<b>D17</b>	BT00.00-X-1000Z	<b>Technical modifications</b>	<b>28.6.99</b>
------------	-----------------	--------------------------------	----------------

BT07.41-P-0001-01A	LH-SFI variable reference resistor modified		<b>F17</b>
BT30.20-P-0001-01A	Routing of cable of electronic accelerator modified	Model 124.036	<b>G17</b>
BT14.10-P-0002-01A	Bolts of exhaust manifold modified		<b>H17</b>
BT14.10-P-0003-01A	Material of exhaust manifold modified		<b>K17</b>
BT14.10-P-0001-01B	Exhaust manifold modified	Model 140 RHS	<b>M17</b>
BT14.30-P-0003-01A	Fit washer of air pump attachment modified		<b>N17</b>
BT14.30-P-0002-01A	Material of air pump carrier modified		<b>O17</b>
BT14.30-P-0002-01B	Material of air pump carrier modified		<b>P17</b>
BT14.30-P-0001-01A	Spacer ring of belt pulley		<b>A18</b>
BT14.30-P-0004-01A	Diameter of air pump belt pulley modified		<b>B18</b>
BT15.12-P-0002-01A	High voltage distributor rotor with stiffening ribs		<b>C18</b>
BT30.10-P-0001-01A	Bell crank of right-hand steering/left-hand steering standardized		<b>D18</b>
BT30.10-P-0002-01A	Return spring between fulcrum lever and accelerator control lever modified		<b>E18</b>

<b>F17</b>	BT07.41-P-0001-01A	LH-SFI variable reference resistor modified	<b>BT</b>
------------	--------------------	---	-----------

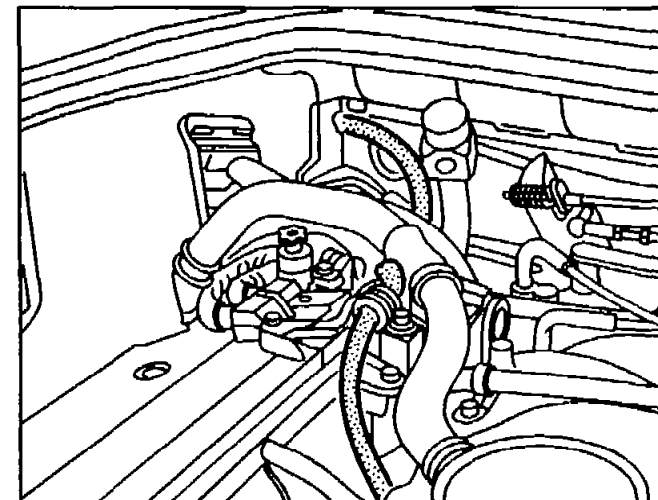
As of 06/91 color-coded variable reference resistors have been installed. Models:

- with TWC green variable reference resistor
  - without TWC white variable reference resistor
- (USA/California version does not have a variable reference resistor)

On models with TWC and national version it is not permitted to install a white variable reference resistor otherwise the secondary air injection pump will run constantly and the air pump may be damaged as a result.

<b>G17</b>	BT30.20-P-0001-01A	Routing of cable of electronic accelerator modified	Model 124.036	BT
------------	--------------------	---	---------------	----

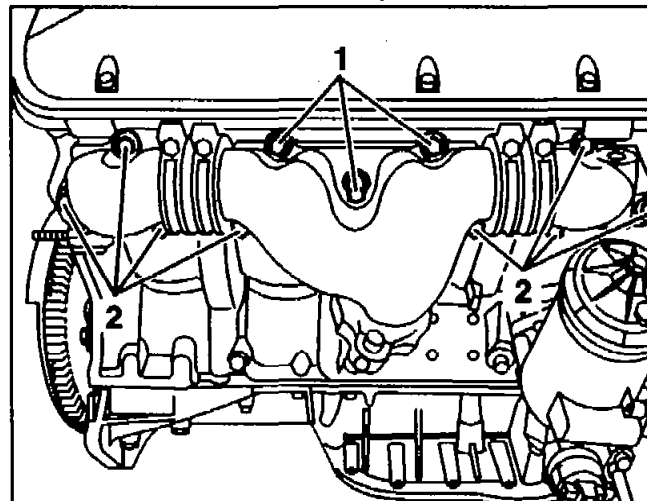
Since 07/93 the routing of the cable has been modified.

<b>H17</b>	BT14.10-P-0002-01A	Bolts of exhaust manifold modified		 <b>BT</b>
------------	--------------------	------------------------------------	--	---

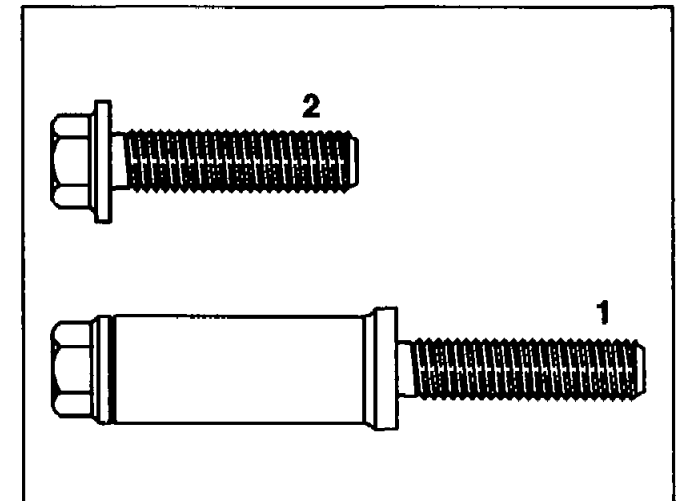
Since about 07/91 only 3 long bolts with sleeve and 8 short bolts without a sleeve have been used for attaching each exhaust manifold.

When performing repairs, this type of attachment can also be installed on models manufactured prior to this date.

K17

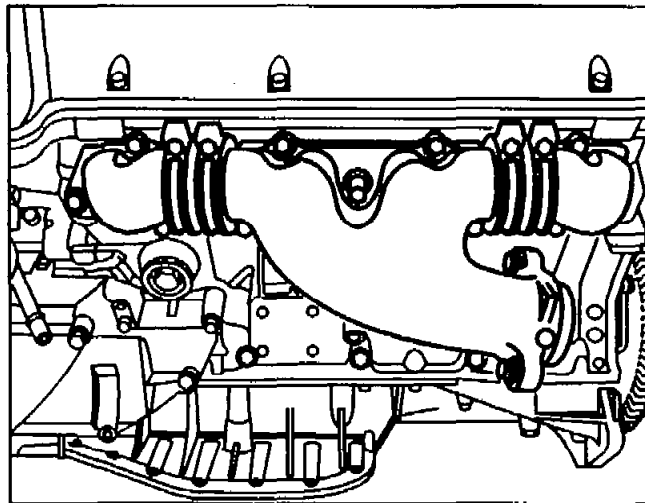
The material of the exhaust manifold for cylinders 1, 4, 5 and 8 has been modified for cost reasons (previously grey cast iron Si Mo 51, now grey cast iron 40). Refer to the standard production breakpoints for the different production breakpoint dates.

<b>M17</b>	BT14.10-P-0001-01B	Exhaust manifold modified	Model 140 RHS	 <b>BT</b>
------------	--------------------	---------------------------	---------------	---

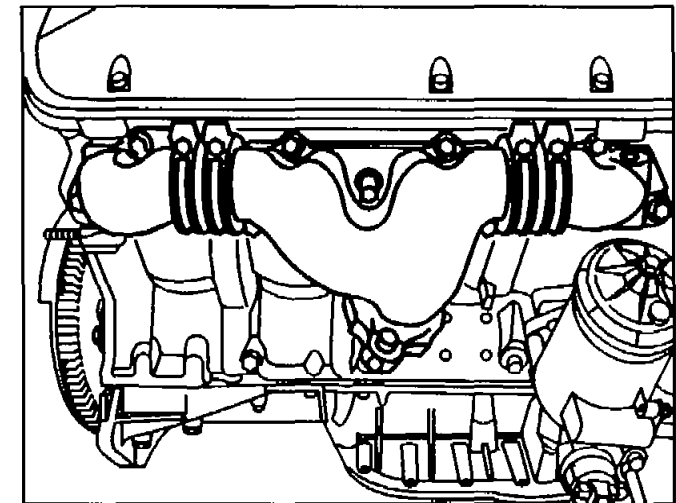
Since about 08/91 the exhaust manifolds have been modified at the flange position. The piping of the exhaust system in the engine compartment has been matched to the modified exhaust manifold.

<b>P17</b>	BT14.30-P-0002-01B	Material of air pump carrier modified	<b>BT</b>
------------	--------------------	---------------------------------------	-----------

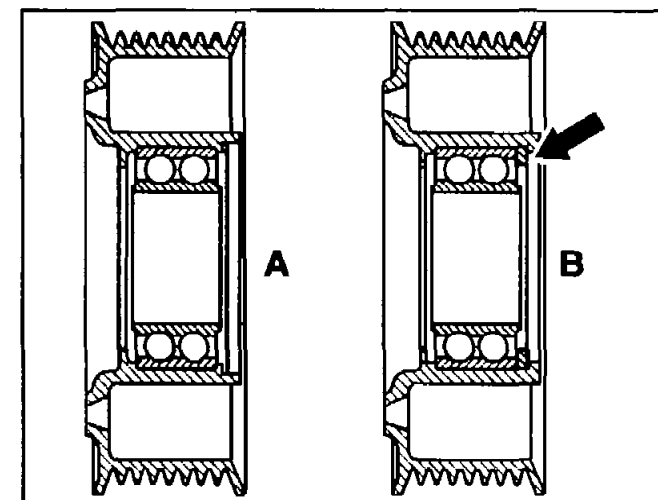
Since 01/92 a modified material has been used for the air pump carrier (GD AL SI 10 MG, was GD AL SI 9 CU3); in addition, the ribs have been reinforced.

<b>D18</b>	BT30.10-P-0001-01A	Bell crank of right-hand steering/left-hand steering standardized		BT
------------	--------------------	---	--	----

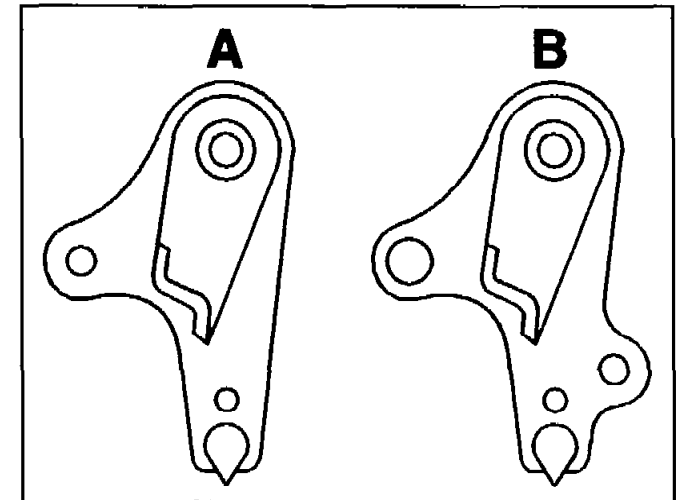
Since 07/91 the bell cranks (8) of right-hand steering/left-hand steering have been standardized.
